Addendum No. 1 **February 14, 2017**

Project: **Lansing Pathway Promise**
Project: SB-0006
Fairview Additions and Renovations

ADDENDUM #1

Project No.:	16-0400	**Date:**	February 14, 2017
Project:	Lansing Pathway Promise SB-0006 Fairview Additions and Renovations Ingham County, Michigan	**A/E Firm:** **Project Manager:**	C2AE Steve Jurczuk
Owner:	Lansing School District 519 West Kalamazoo Street Lansing, MI 48933

1 SANITARY & VENT ISOMETRIC - EAST WING

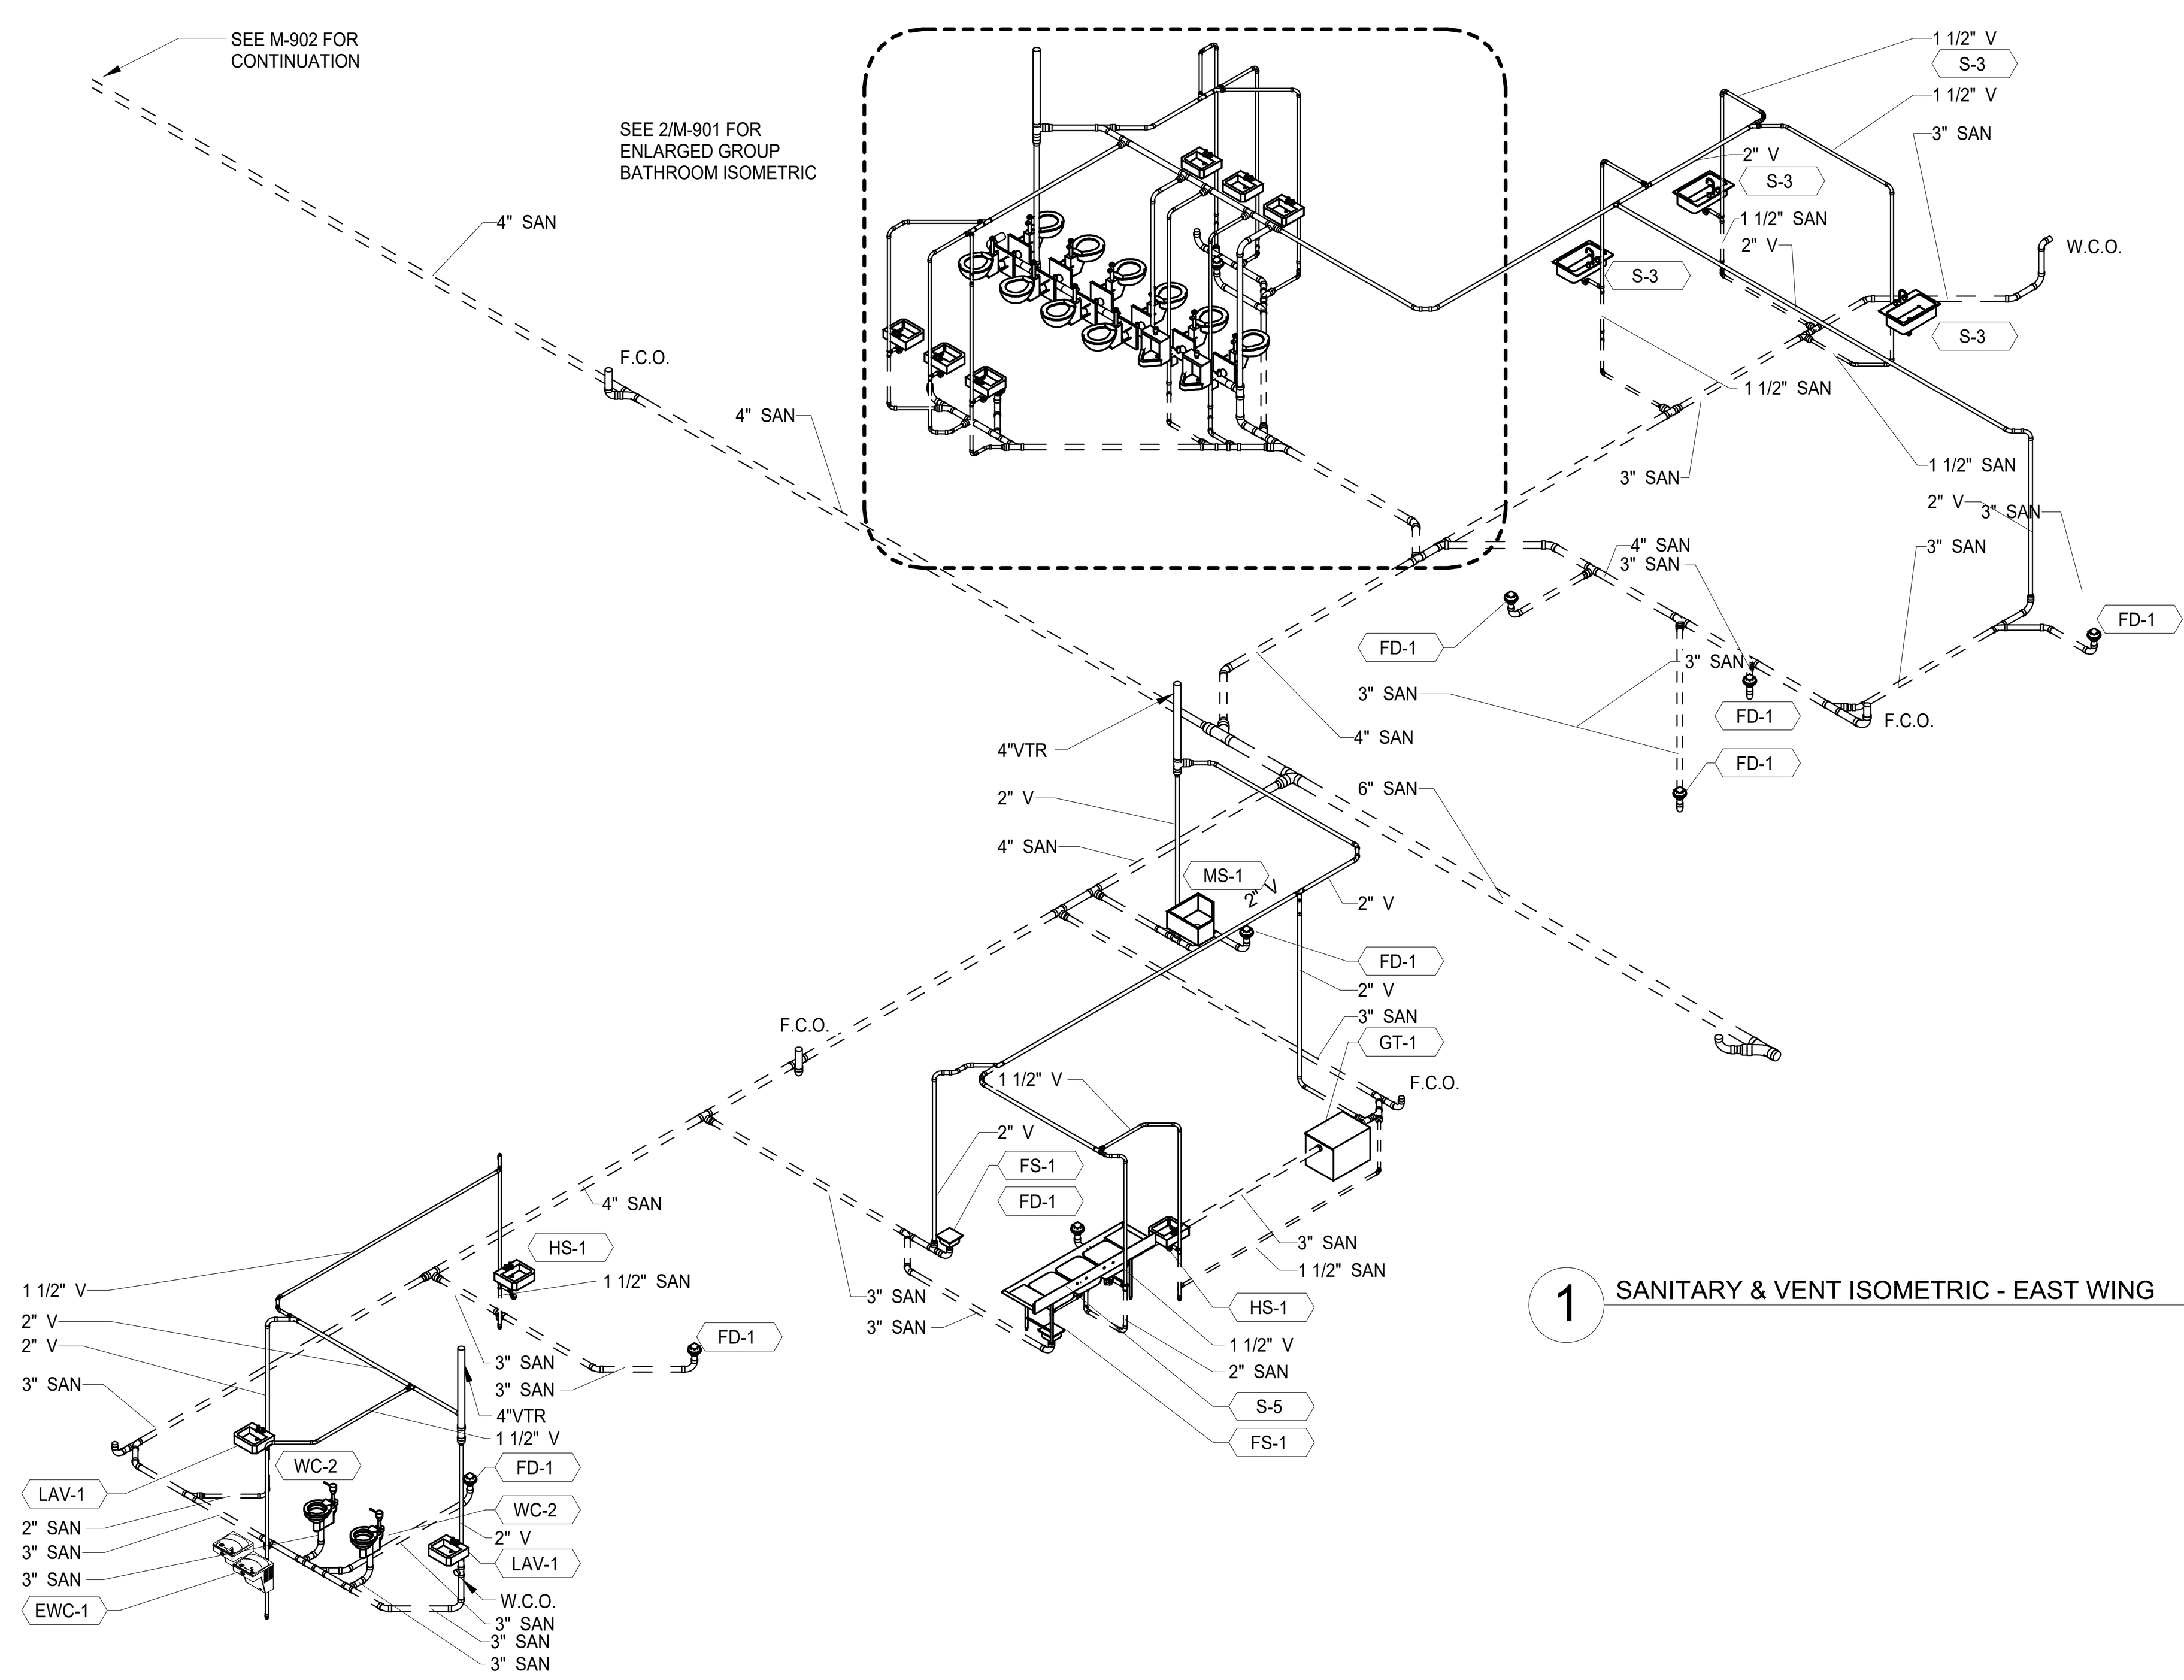
A1.38 Refer to Sheet P-901 (reissued):
REVISE sanitary piping isometric for new bathroom fixture layout as shown.

DATE 02/13/2017
SHEET P-902
PROJ # 160400
SCALE

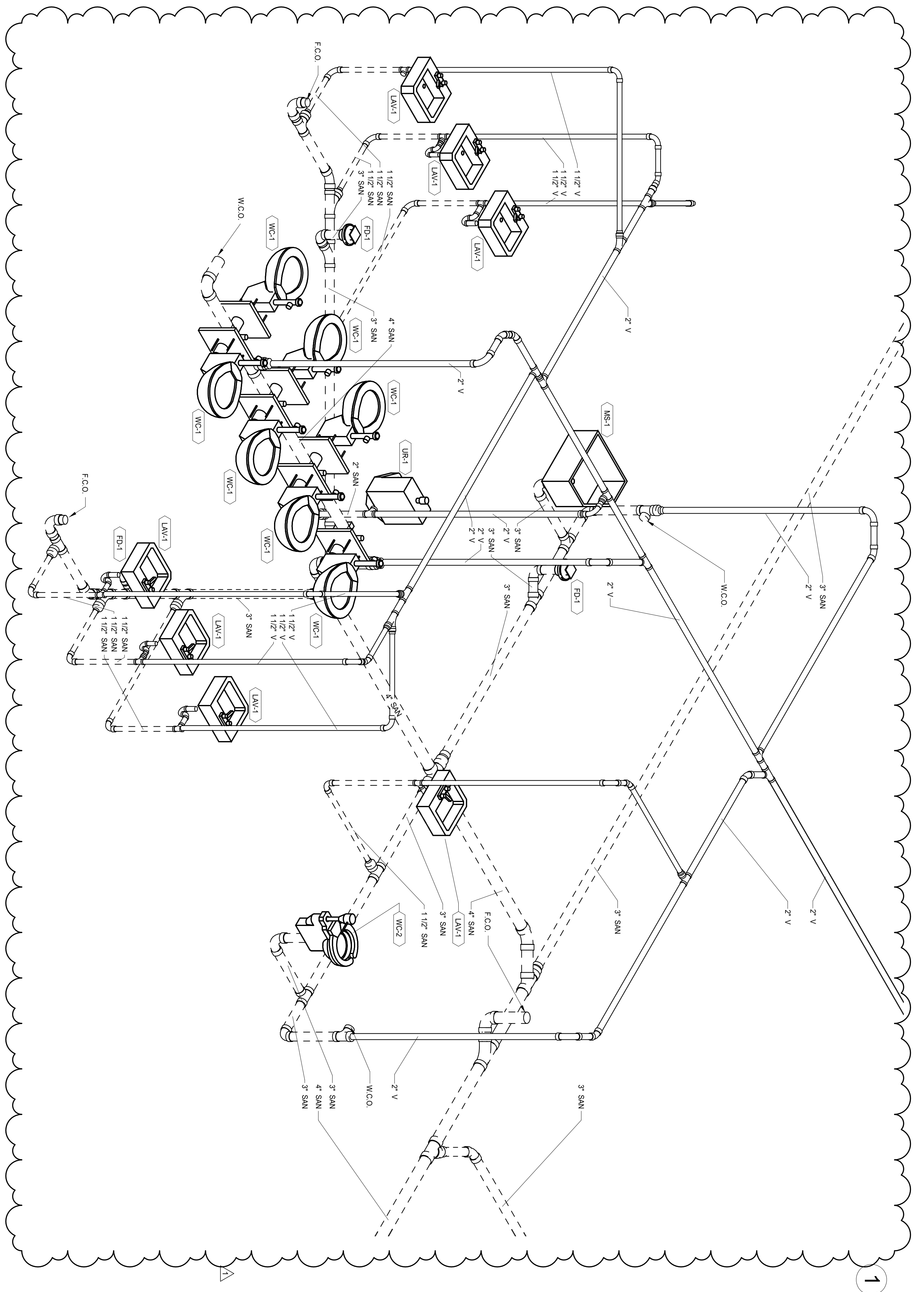
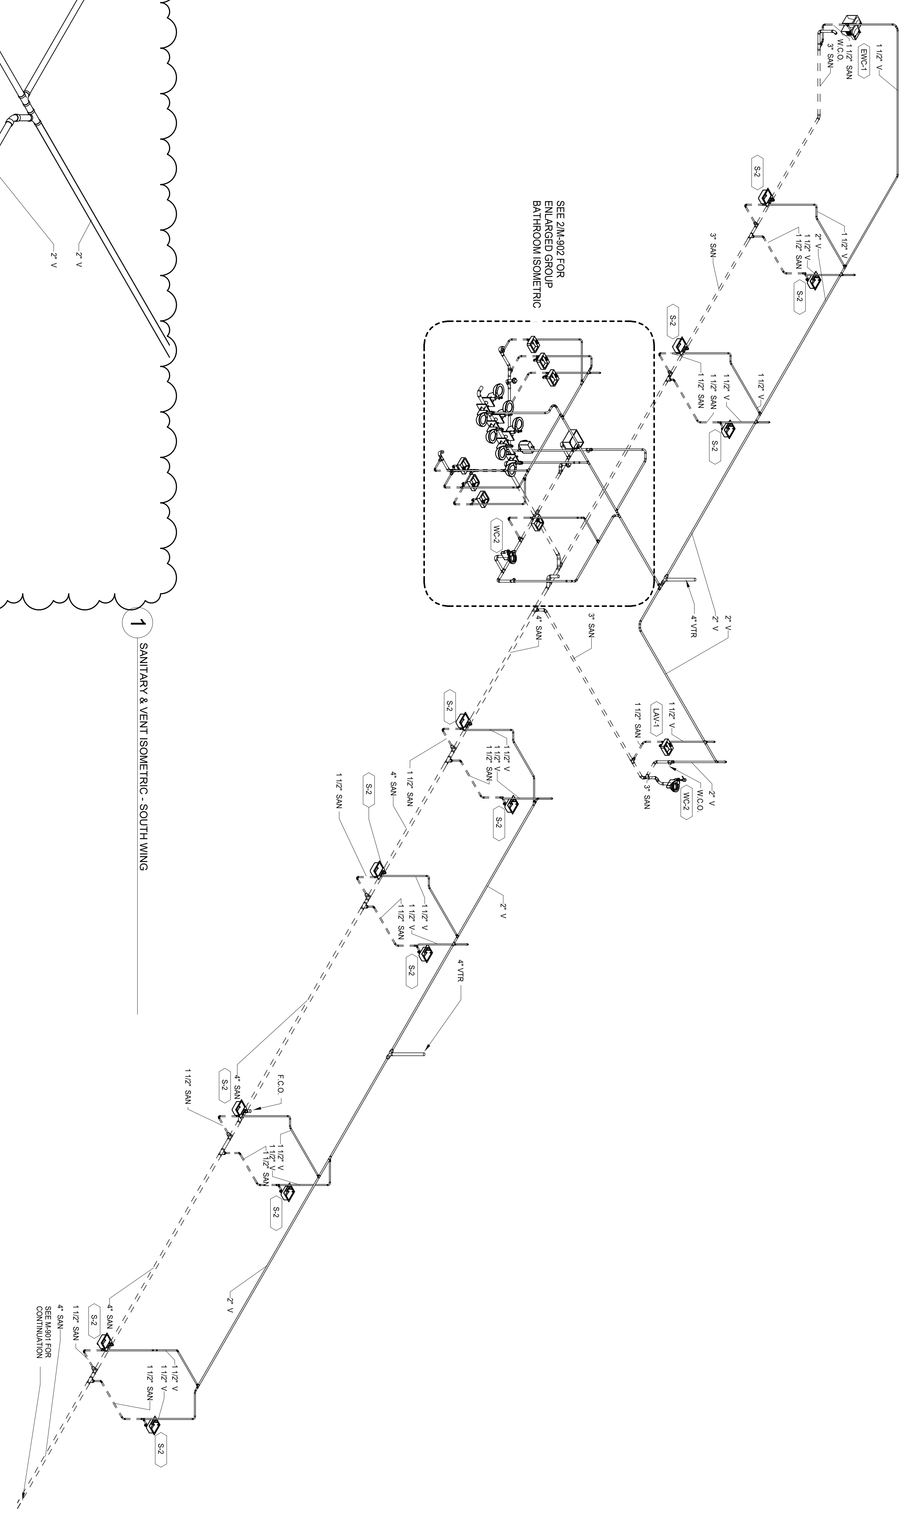
A1.39 Refer to Sheet P-902 (reissued):
REVISE sanitary piping isometric for new bathroom fixture layout as shown.

2 CONDENSATE DRAIN TO INDIRECT WASTE DETAIL
N.T.S.

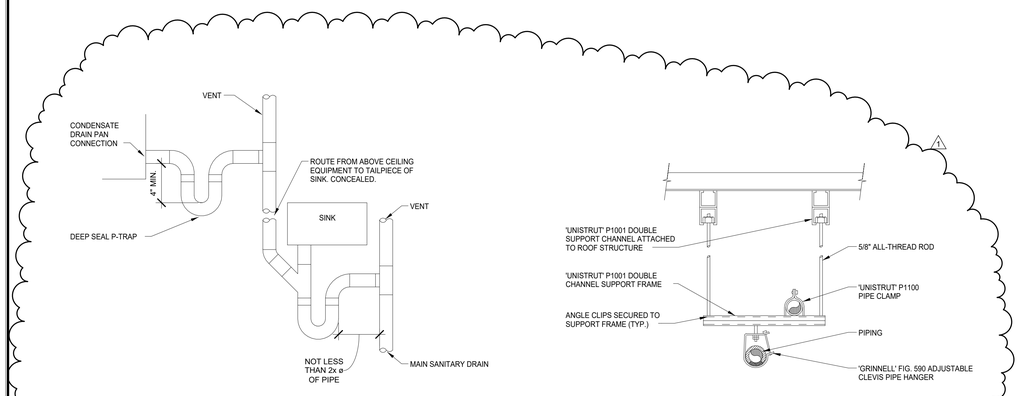
A1.42 Refer to Sheets M-111.A, M-111.B, M-111.C, M-111.D, M-111.E (reissued):
- See detail for directions on draining condensate as noted on plans.
- See detail for pipe support directions.

3 ENLARGED KITCHEN POWER PLAN
1/4" = 1'-0"

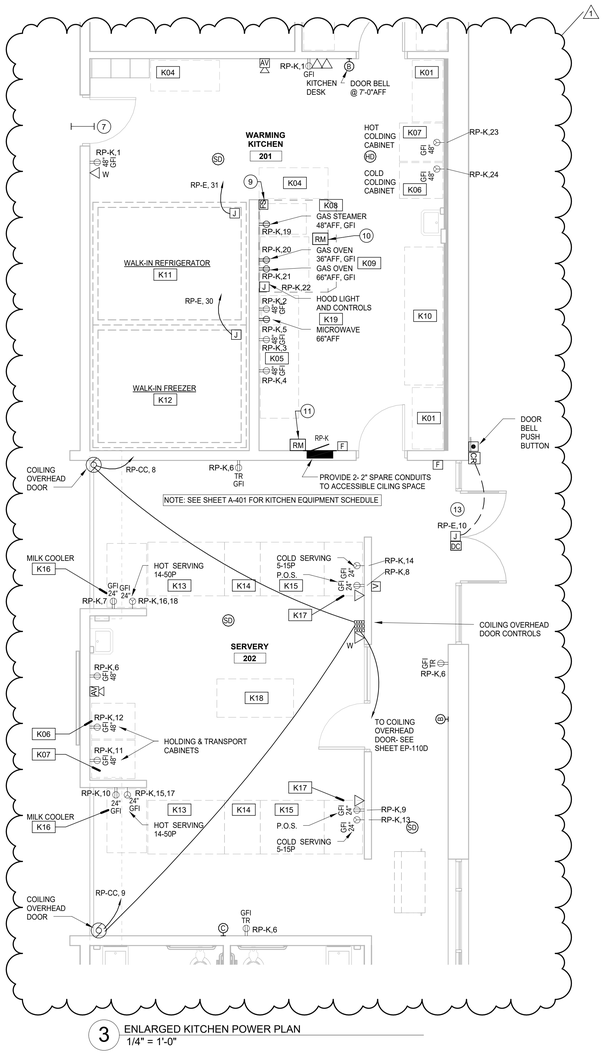
In the Kitchen 201 and Servery 202, REVISE the receptacles indicated to GFCI type.

2 POWER DISTRIBUTION ONE-LINE DIAGRAM
N.T.S.

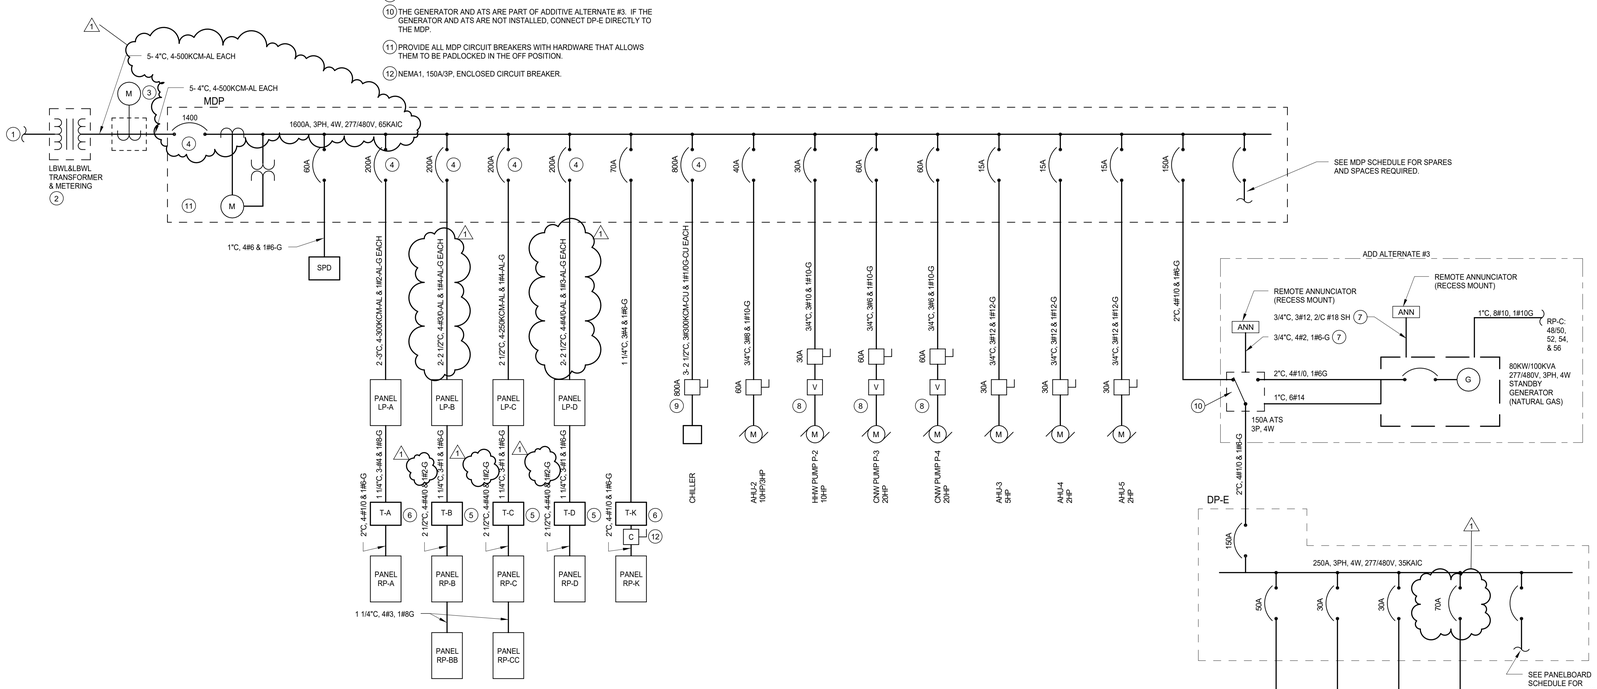
In the One-Line Diagram, REVISE the circuit breaker sizes and conductor sizes as indicated.
